Basin Pump Station Improvements Phase II Project  
SAWS Job No. 15-6004  
Solicitation No. CO-00163

**ADDENDUM No. 2**

March 30, 2018

S-302

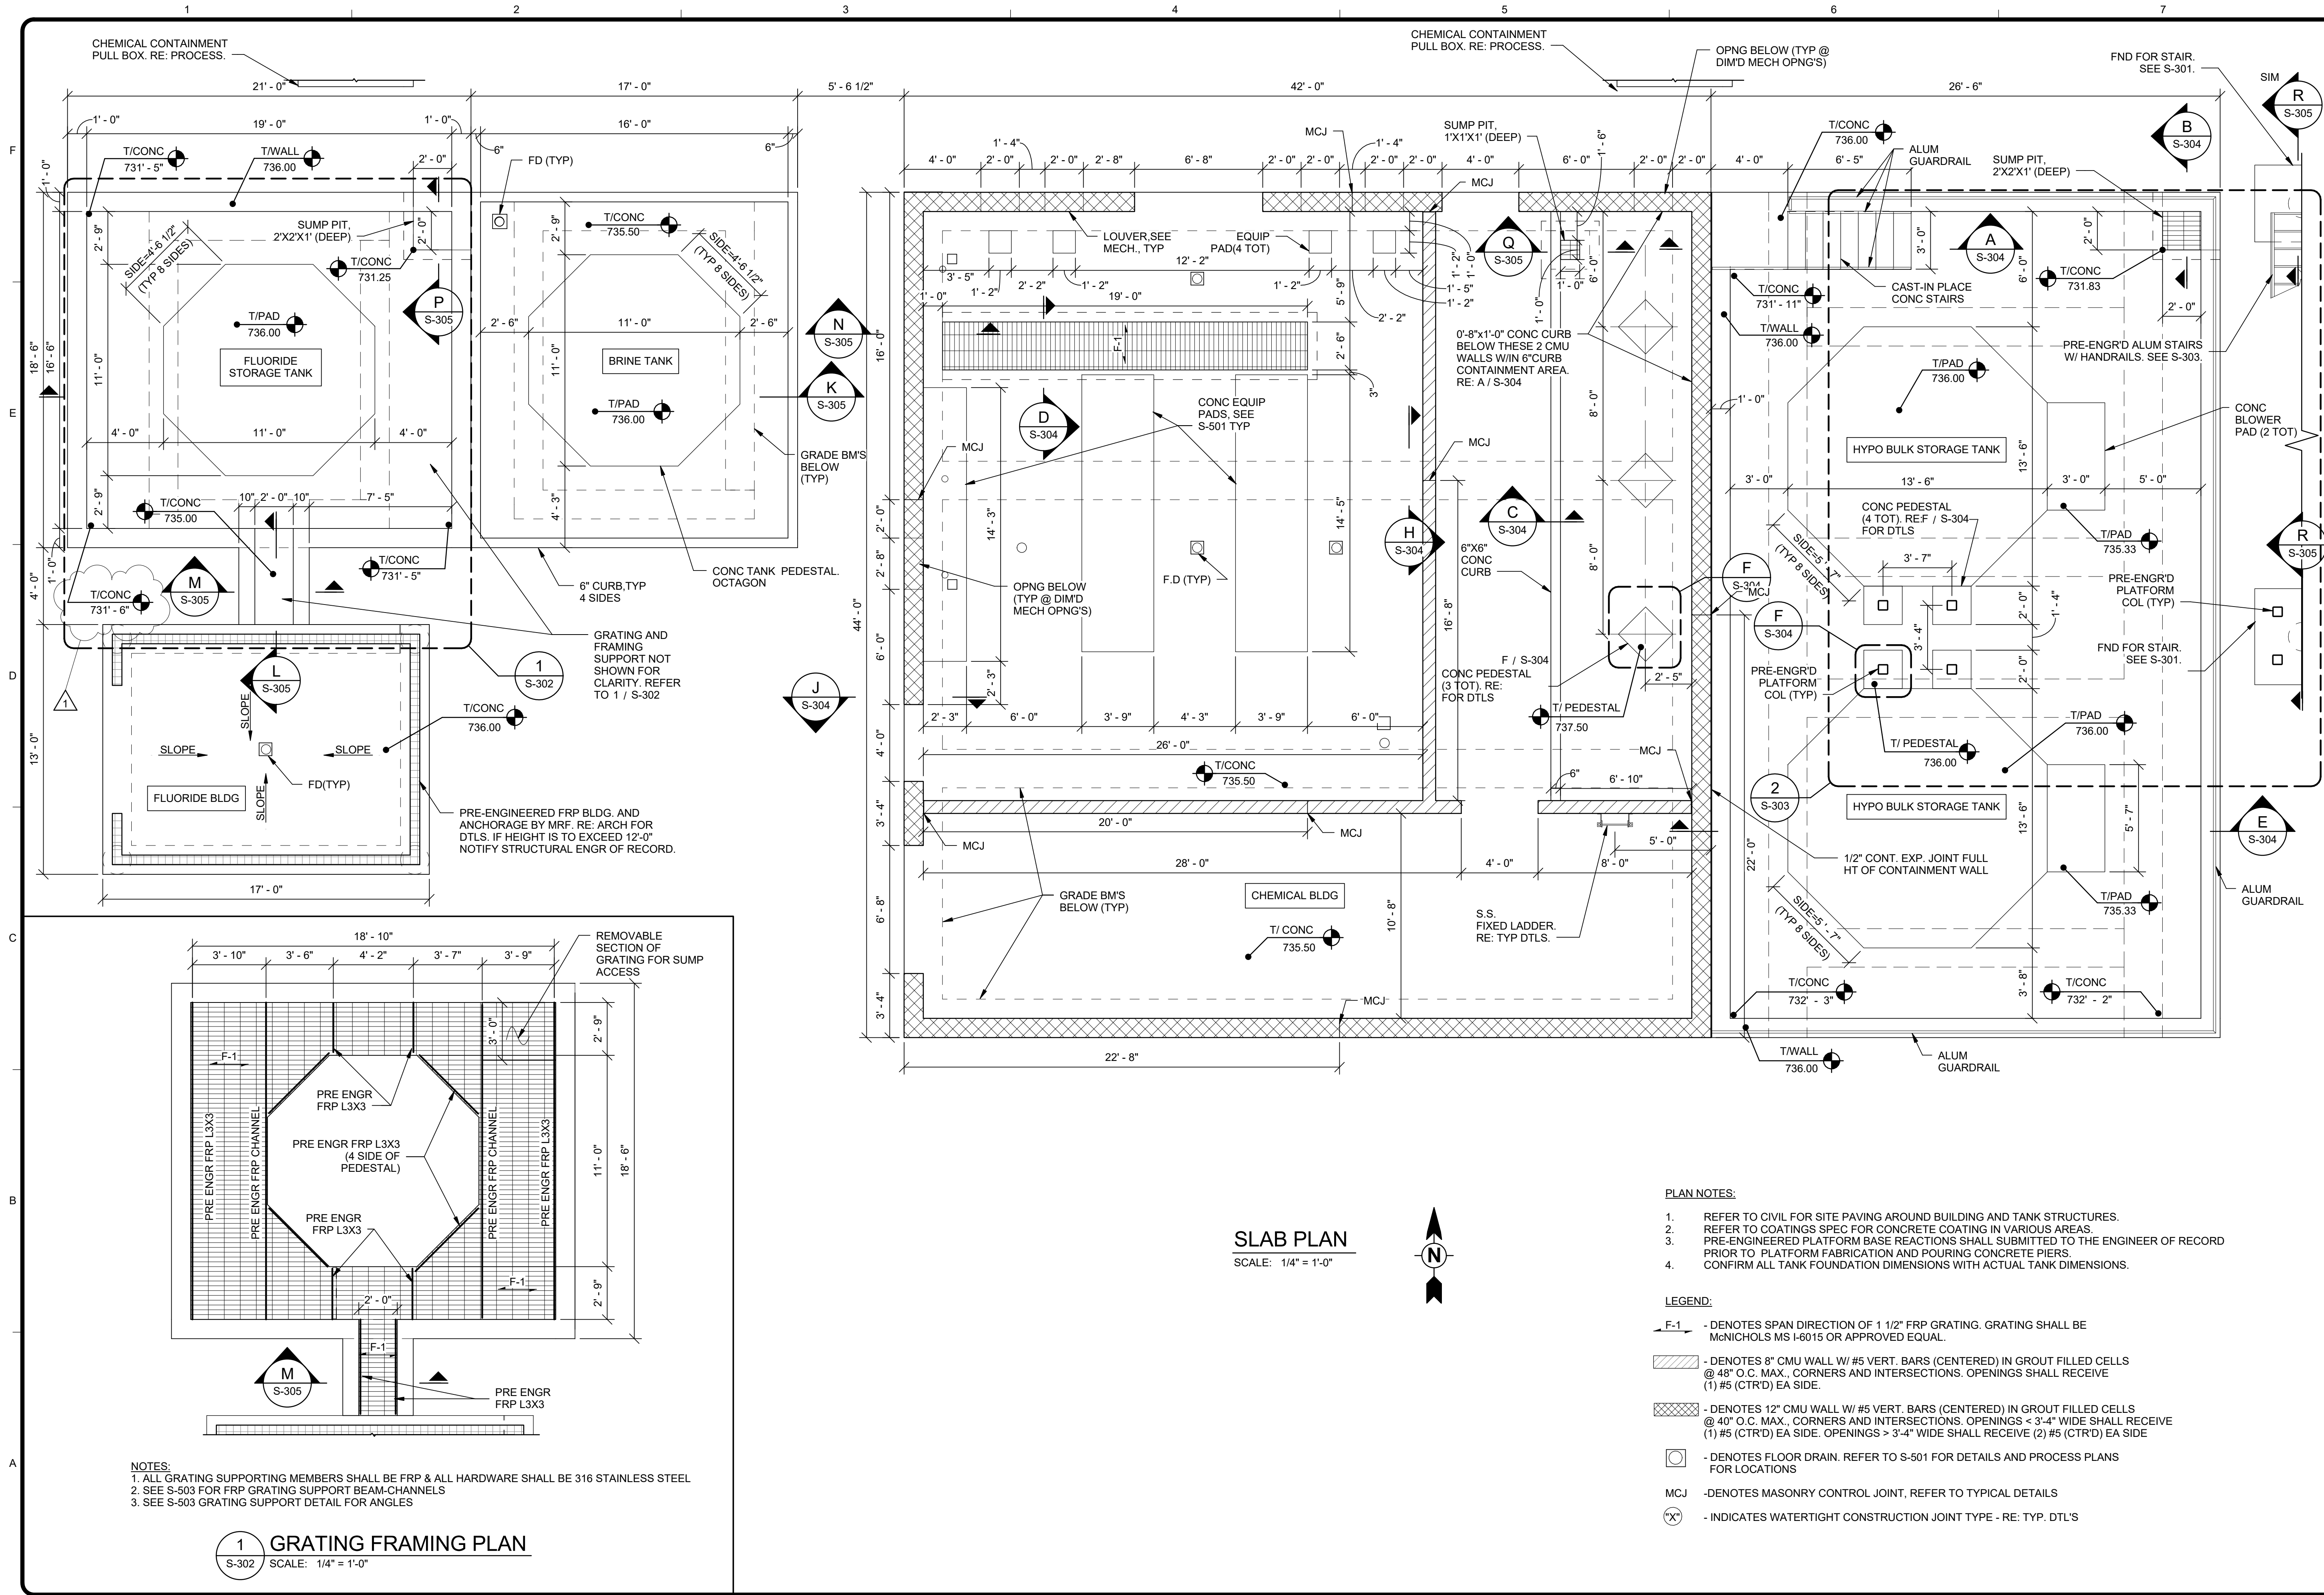
- 1.16.** Drawing S-302, Fluoride Storage Tank Pad, lower left corner of SOG indicates a TOC elevation of 729’-7”. This would pool water in this corner instead of flow to the sump. Should it read 731’-7” instead?

- 1.18.** Drawing S-302 indicates a ½” continuous expansion joint full height of containment wall, between the Chemical Building and the Hypo Bulk Storage Tank Building. The note is located on the southern tank elevated pad. Drawing C-301 indicates to construct an expansion joint per Detail 6/ C-502. Detail 6/ C-502 includes a slip dowel assembly and appears to indicate a joint between the new PCC drive and sidewalk, as concrete drive is indicated. Please confirm the correct detail for the location between the two buildings?

**Response:** Lower left (south-west) corner should read 731’-6”. See updated plan on S-302 attached herein.

**Response:** There should not be dowels between the Chemical Building and the Hypo Bulk Storage Tank Building. A ½” continuous expansion joint full height of the containment wall is correct. Refer to part 3, Modifications to the Drawings, Item 3.9 and 3.11 herein.
